Service Documentation

RevD 16/05/08

AMIS480P POWER AMP

CD6330-1

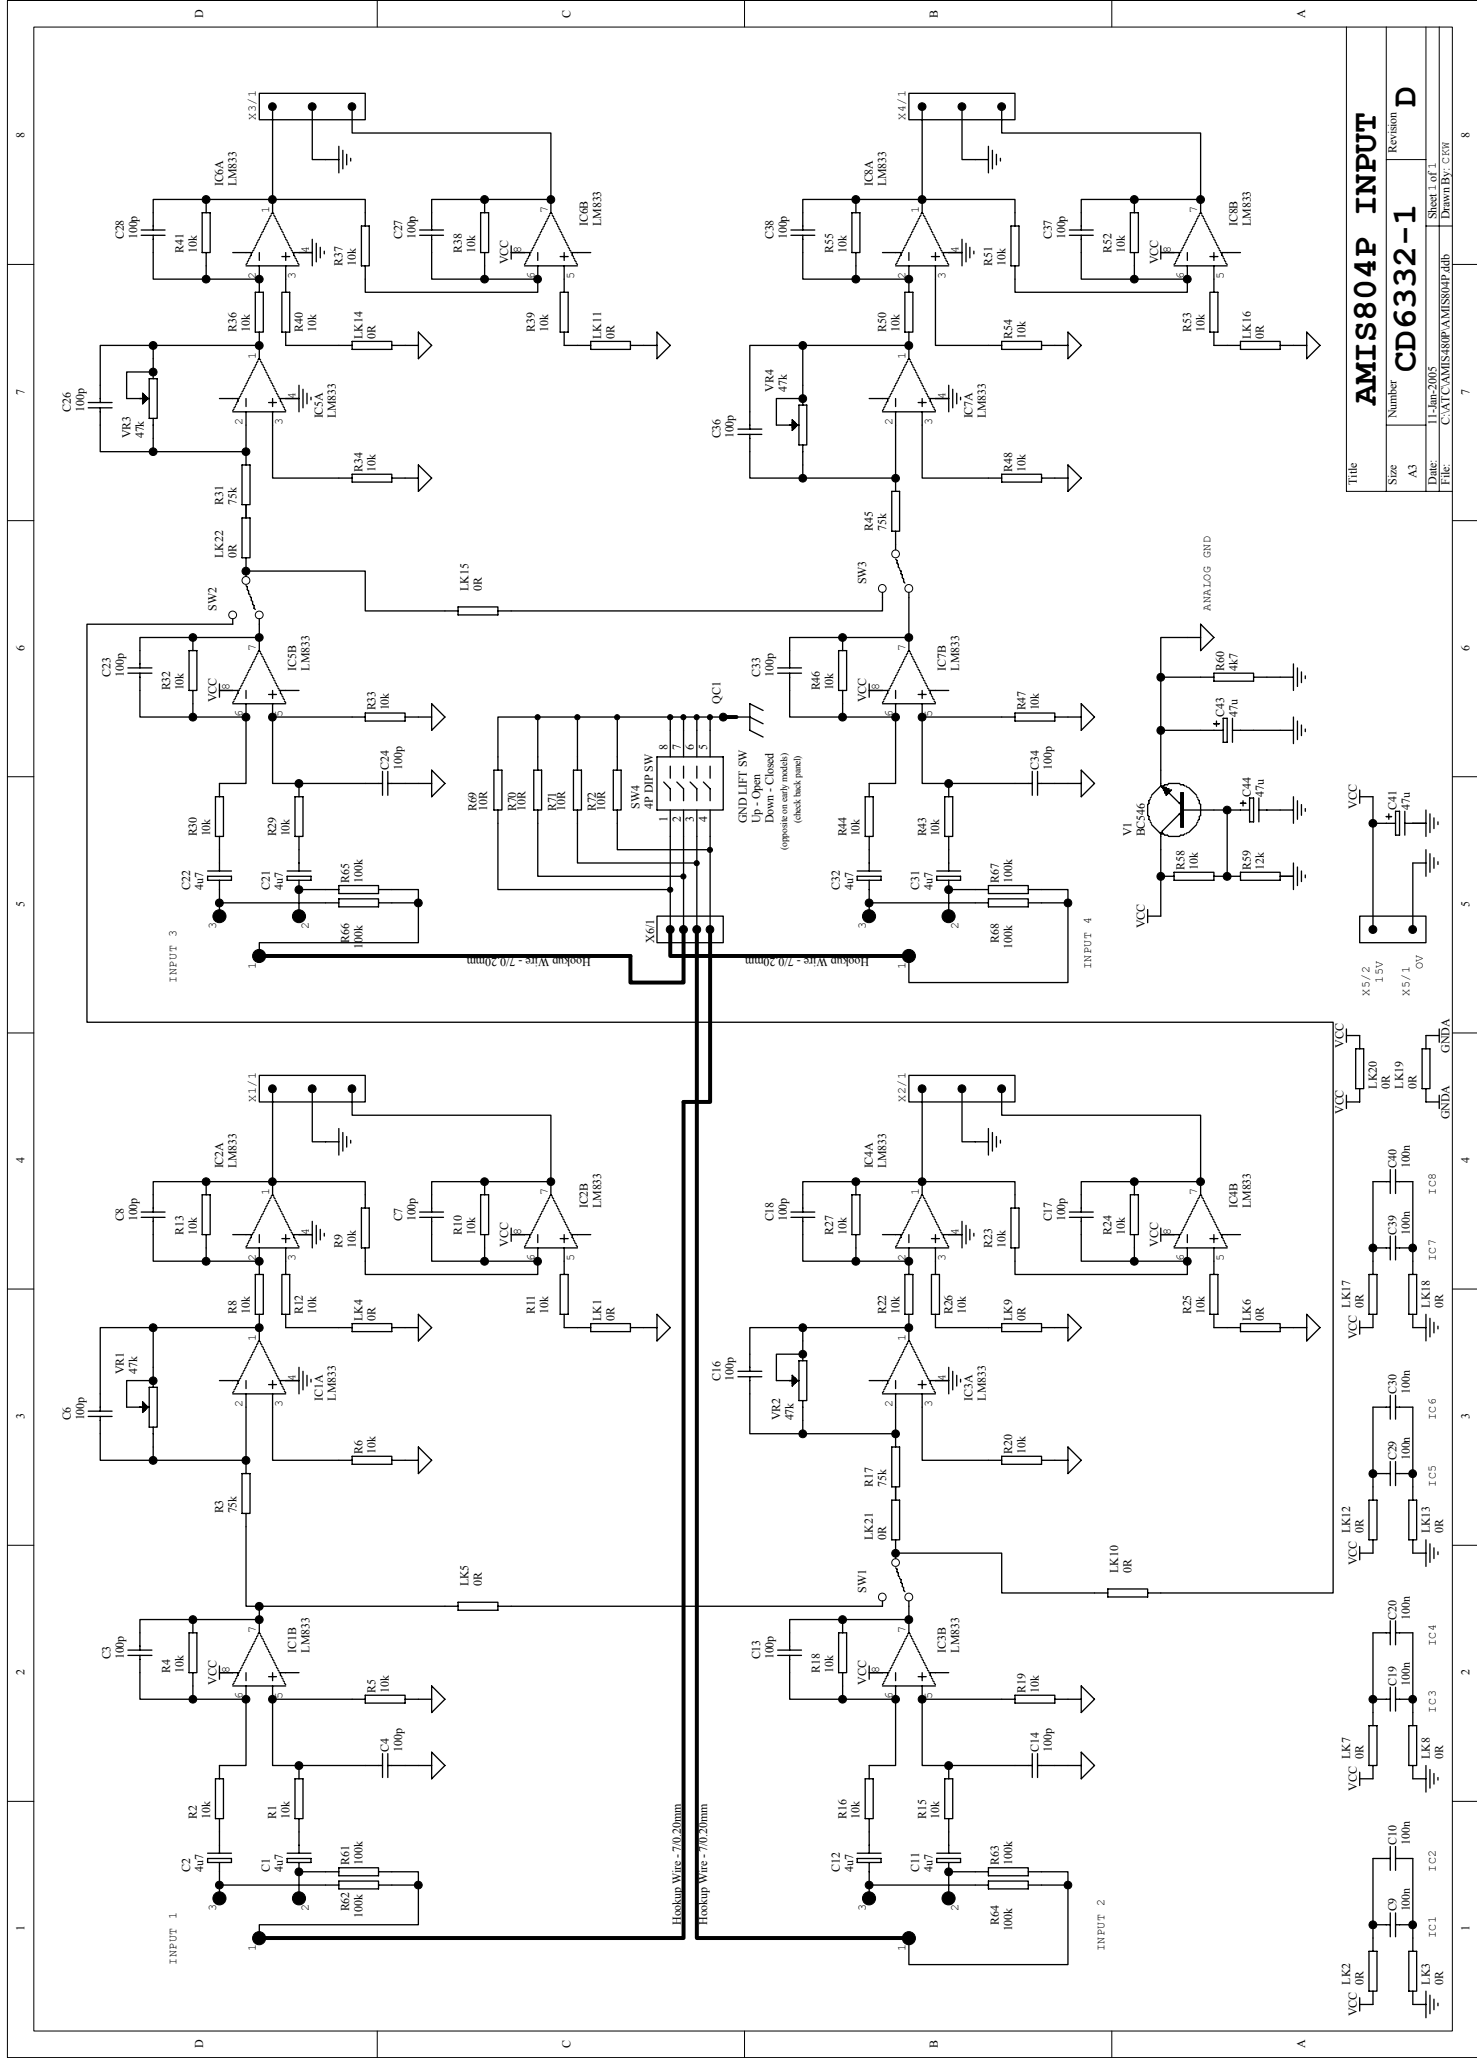
CD6330-1 RevD to RevE

Added thermal switch to bridge rectifier

Removed PCB overlays
